MONTGOMERY COUNTY HISTORIC PRESERVATION COMMISSION
STAFF REPORT

Address:	402 Tulip Ave., Takoma Park	Meeting Date:	8/15/18
Resource:	Contributing Resource Takoma Park Historic District	Report Date:	8/8/18
Applicant:	Sara & Anthony Camilli	Public Notice:	8/1/18
Review:	HAWP	Tax Credit:	n/a
Case Number:	37/03-17X REVISION	Staff:	Dan Bruechert
Proposal:	Window, Door, and Siding Alterations

PROPOSED FRONT (SOUTH) ELEVATION

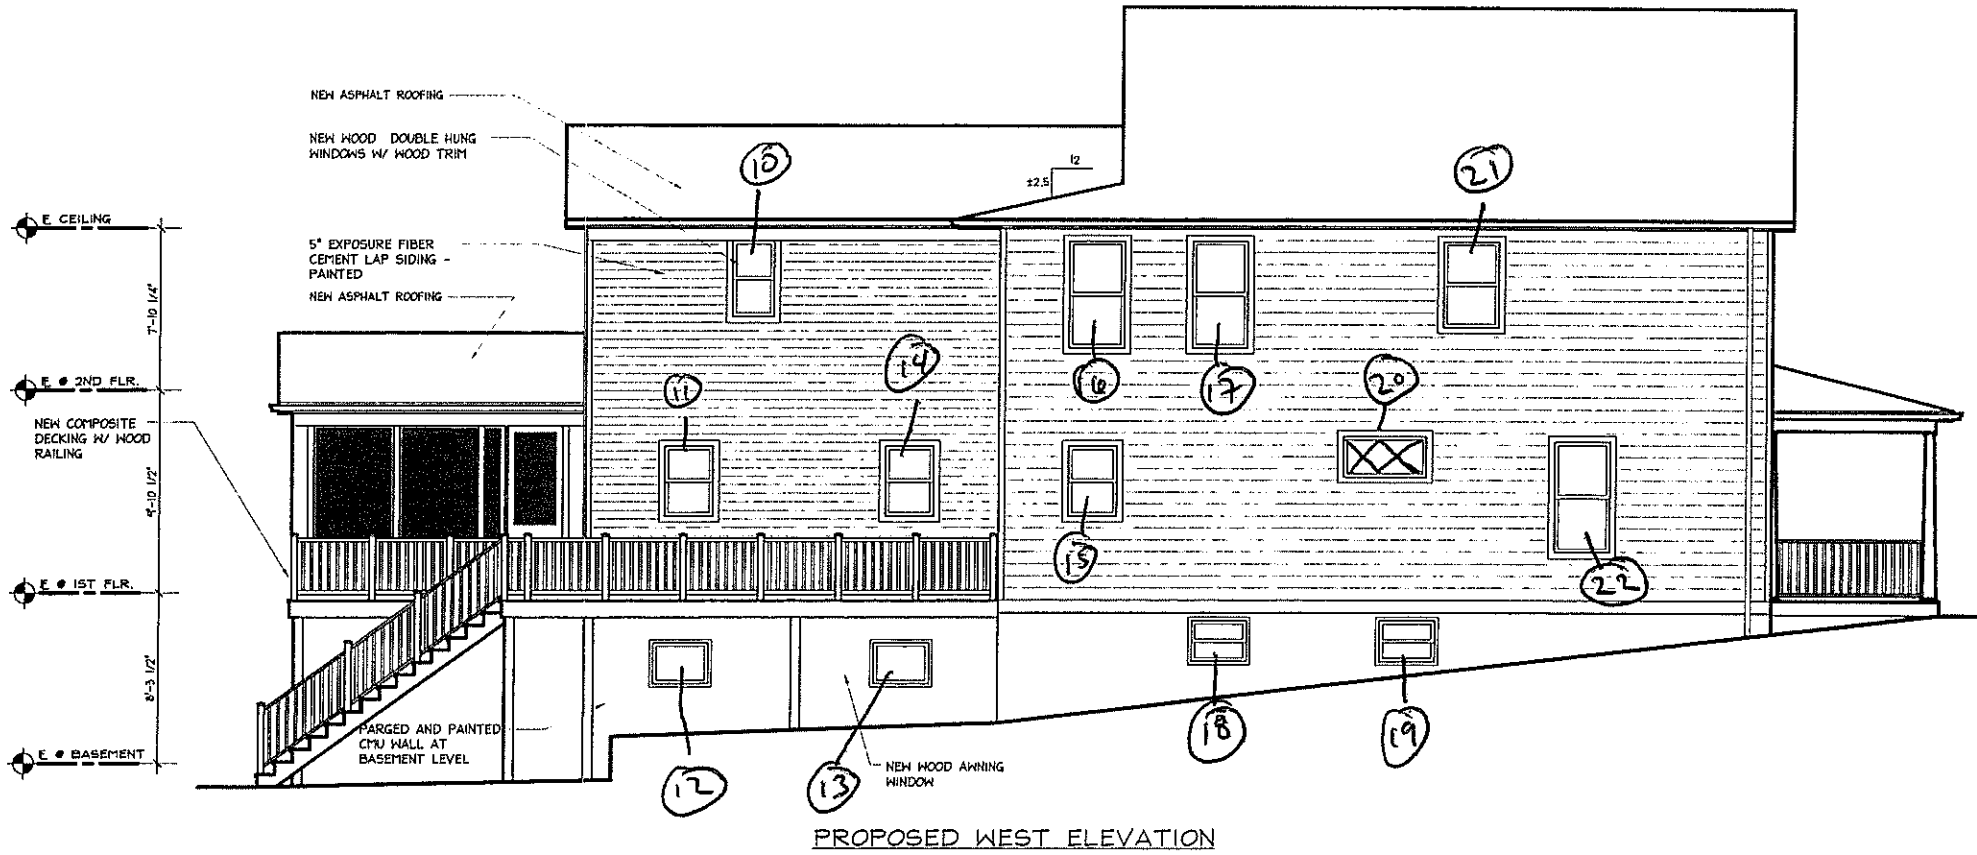
On the side gable addition, the previous approval included a pair of one-over-one sash windows. The applicant now proposes to install a single sash window in its place. This design revision does not result in a significant alteration to the approved design and does not impact the historic character of the house. Staff Supports approval of this revision.

PROPOSED WEST ELEVATION

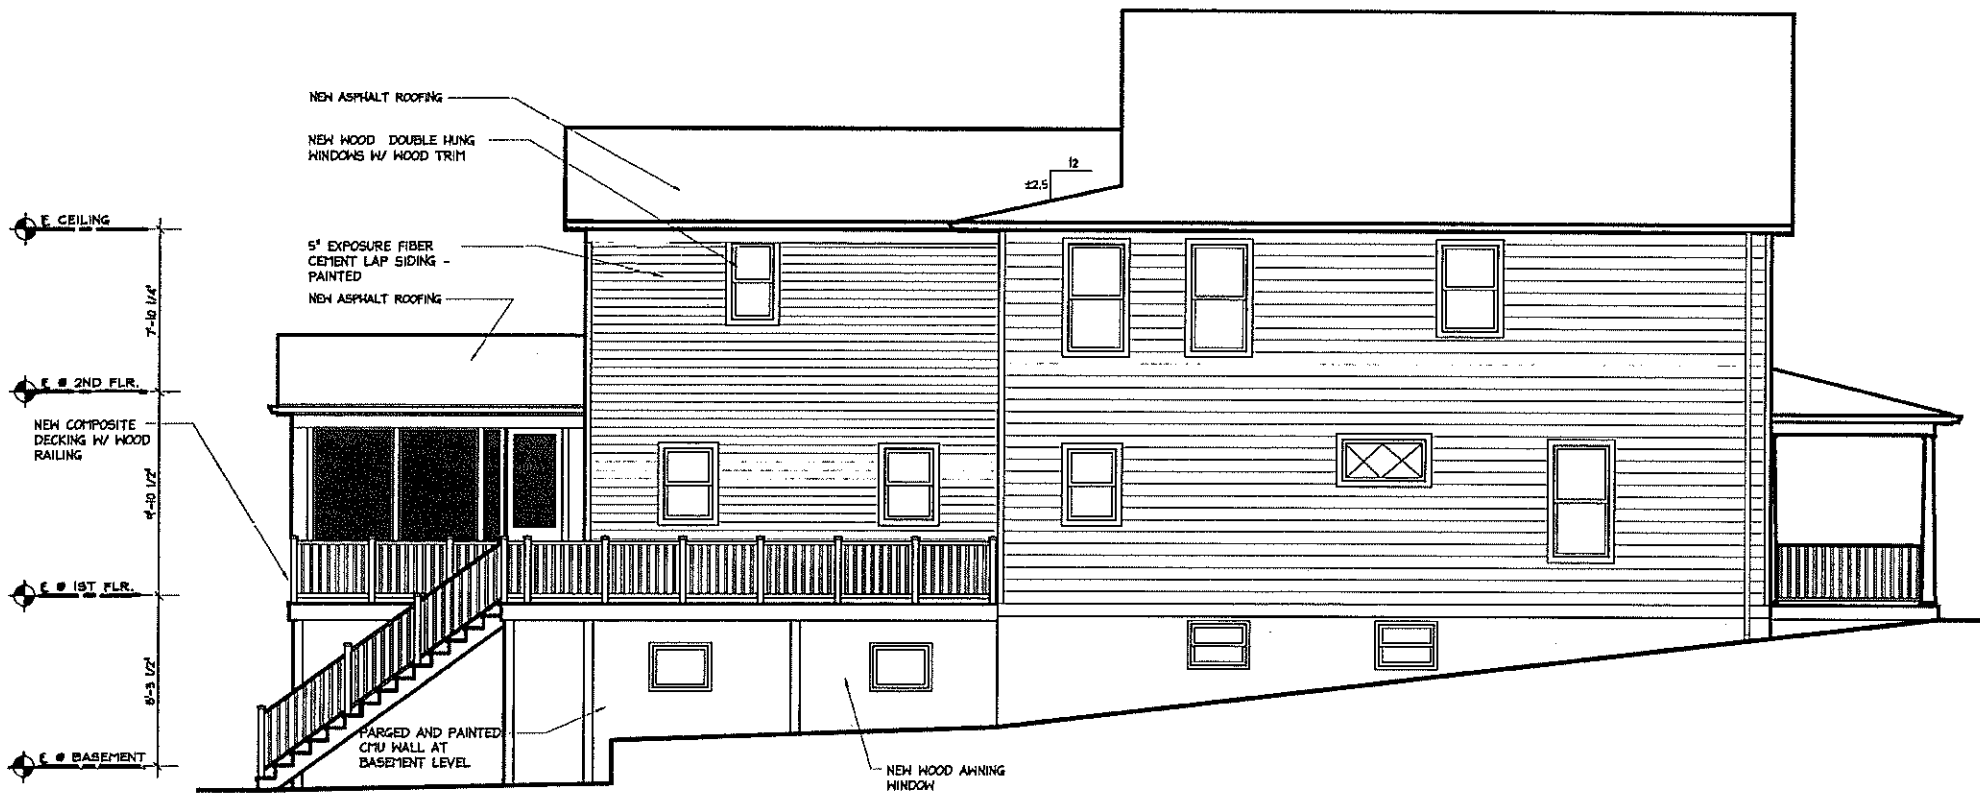
On the west elevation at the basement, the approval allowed for a single full-light door and a one-over-one sash windows. The applicant now proposes to install two one-light awning windows. These windows are below street grade and inset from the west wall plane and will not be visible from the public right-of-way. Per the *Design Guidelines* this revision should be approved as a matter of course.

On the second floor of the west elevation, the applicant is proposing to remove one approved one-over-one sash windows from the design. The alteration to the fenestration pattern will likely be minimally visible from Willow Ave., but its impact on the historic resource will be minimal (per the *Design Guidelines*) and the wall pattern will still be in character with the surrounding district. Staff supports approval of the modifications to the West elevation.

PROPOSED EAST ELEVATION

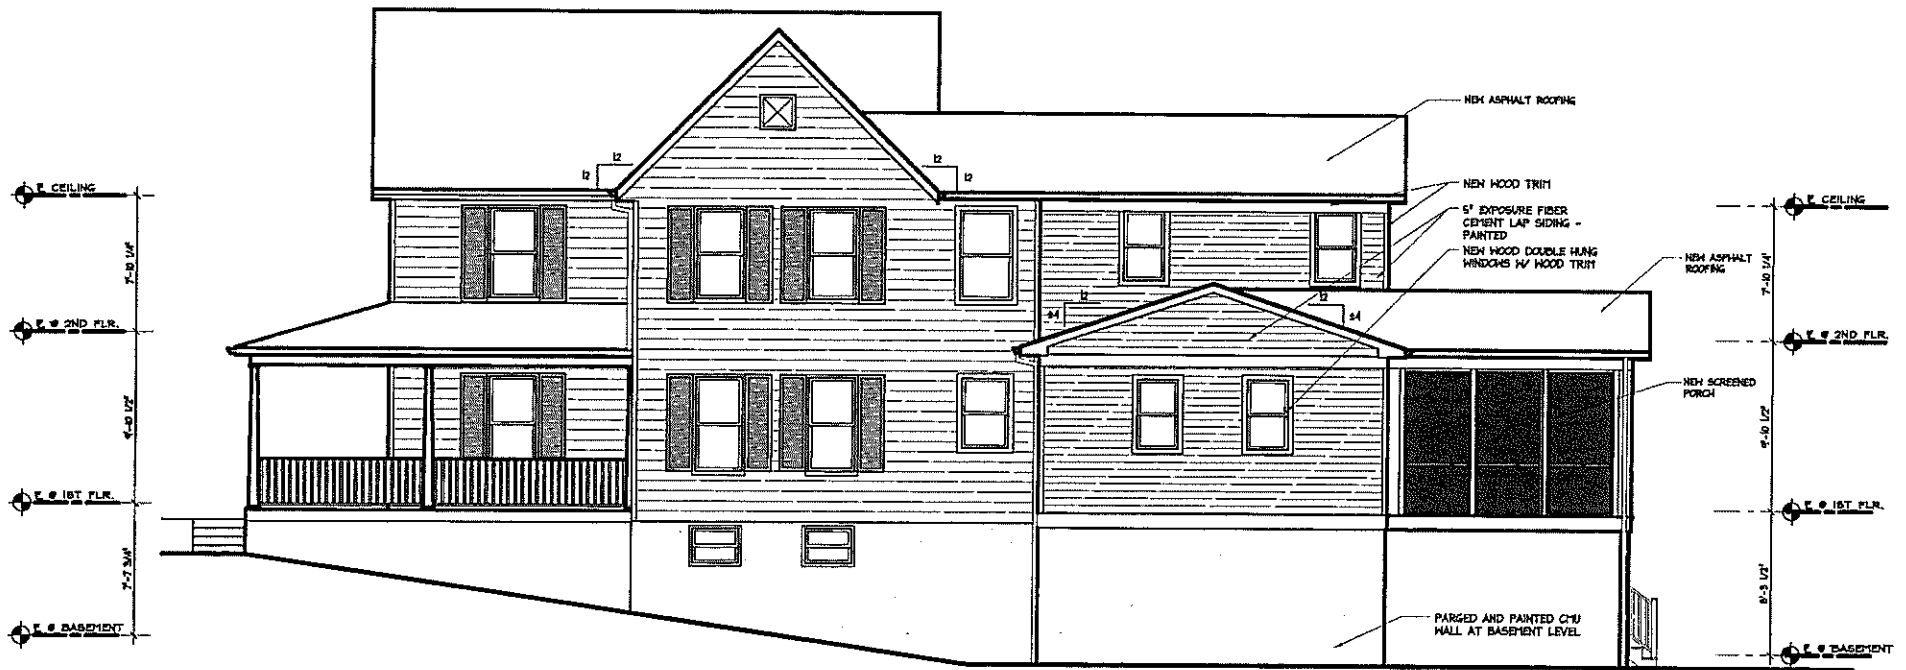
The applicant proposes to narrow the two windows in the side-gable (garage) addition on the first floor. This change is minimal from the previous approval and due to the narrow side setback of the east elevation, this change will not be readily visible from the public right-of-way.

PROPOSED REAR (NORTH) ELEVATION

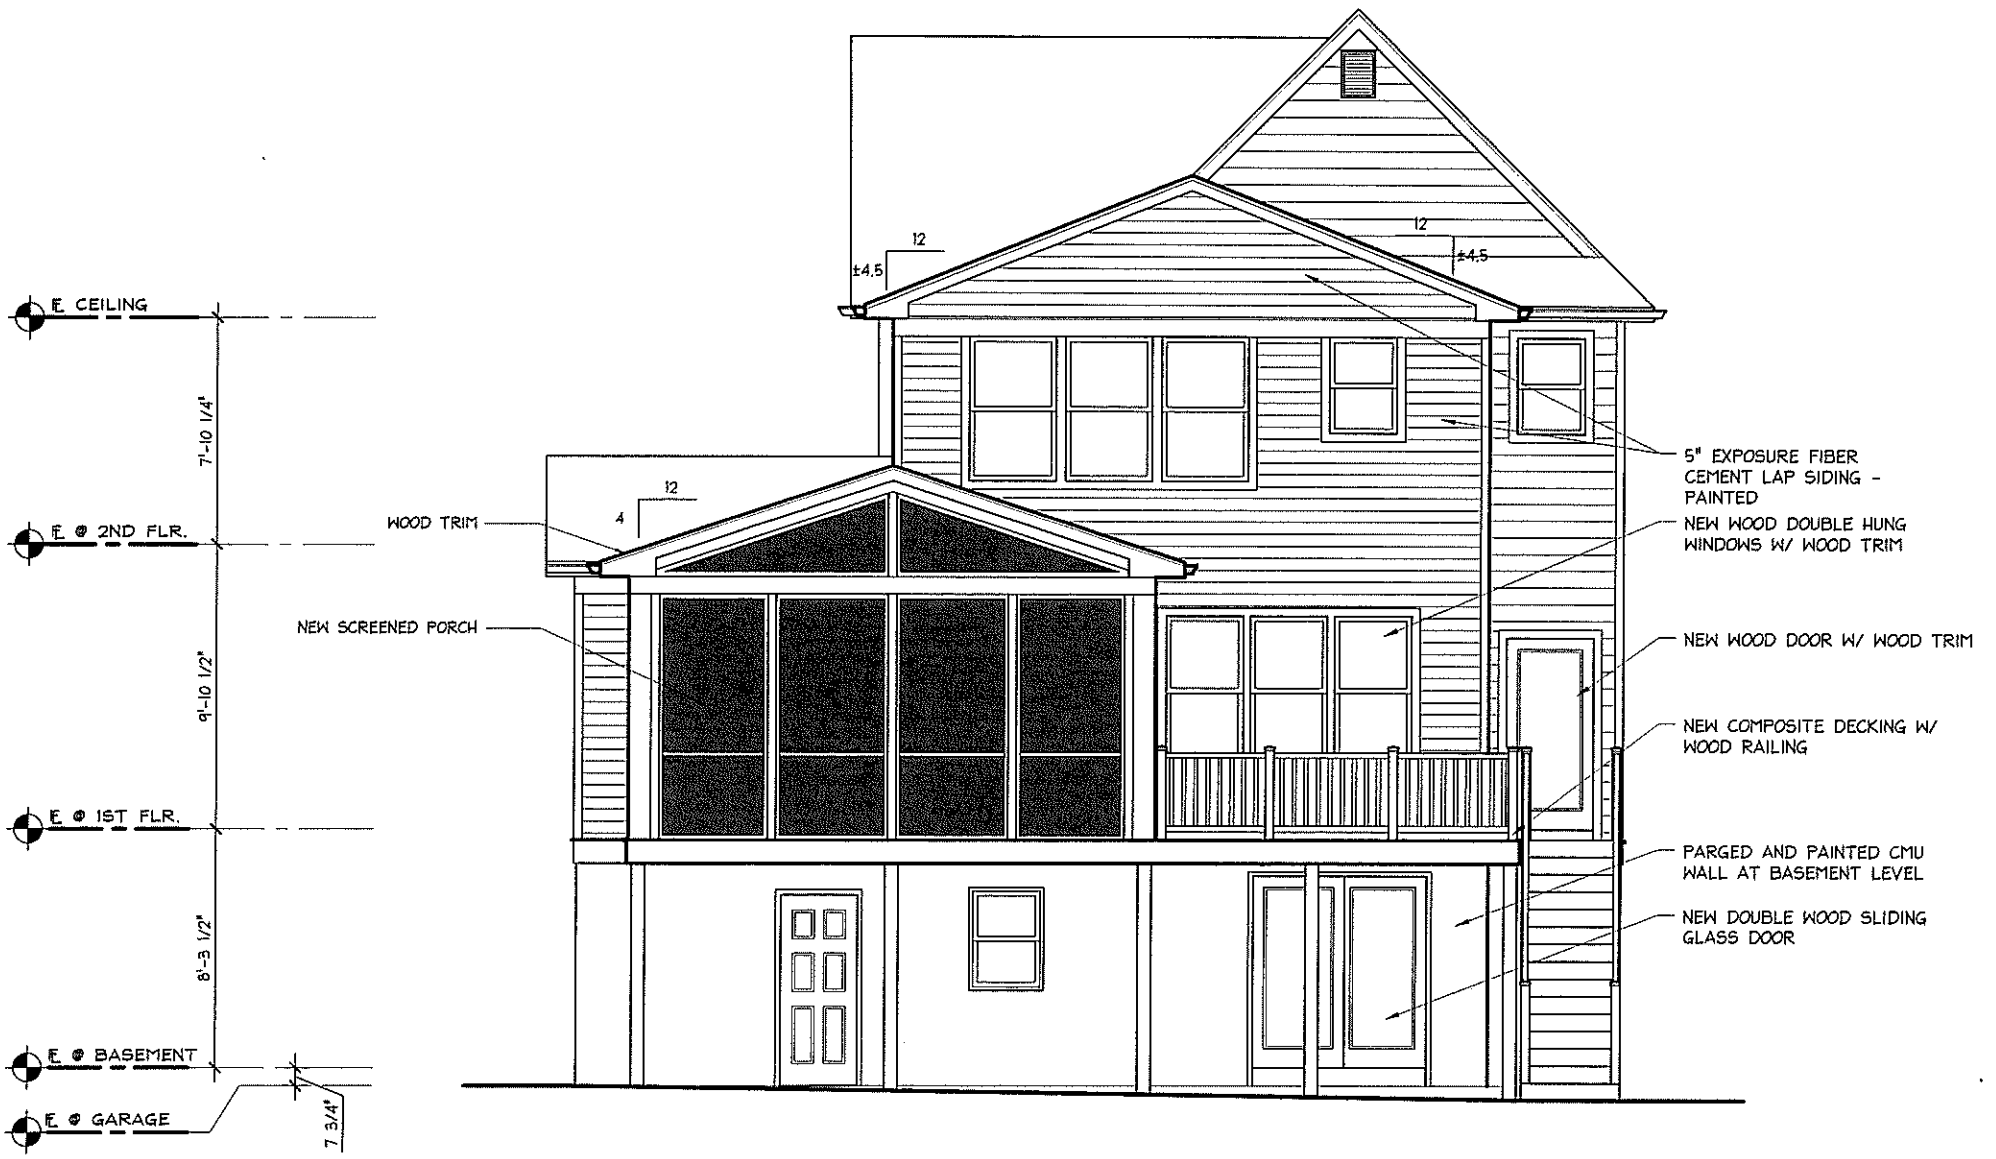
On the basement of the north (rear) elevation the applicant is proposing alterations to all three floors. At the basement the applicant proposes to install a set of wood sliding glass doors in the basement. These doors will be installed under the back porch in an area that was blank when it was previously approved. This portion of the house is not visible from the public right-of-way and will not change the character of the house. Staff supports approval of this revision.

On the first floor of the house, the applicant proposes changing a pair of one-over-one sash windows to a tripled set of one-over-one sash windows. While this will reduce the ratio of solids to voids, this is proposed on a new feature of the house and will not impact its historic character. Staff supports approval of this revision.

On the second floor, the applicant proposes changing a pair of one-over-one sash windows to a tripled set of one-over-one sash windows. While this will reduce the ratio of solids to voids, this is proposed on a new feature of the house and will not impact its historic character. Staff supports approval of this revision.
